SAFETY RECALL BULLETIN

NHTSA RECALL 19V622

AUTOCAR, LLC SAFETY RECALL ACX-1907

Power Steering Pump Fasteners for Xpeditors with Cummins Engines

Figure 3, Cummins L9

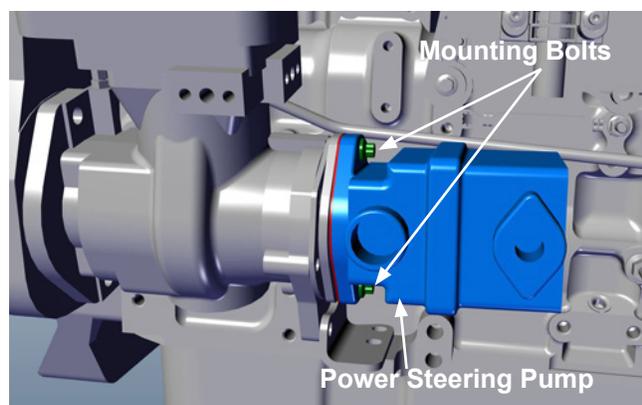
3. Remove the power steering pump mounting bolts, one at a time, for the Cummins L9 engine (see Figure 3), or for the Cummins X12 engine (see Figure 4). Apply blue thread locking compound (obtain locally) and tighten to 34 lb-ft (46 N·m) of torque.
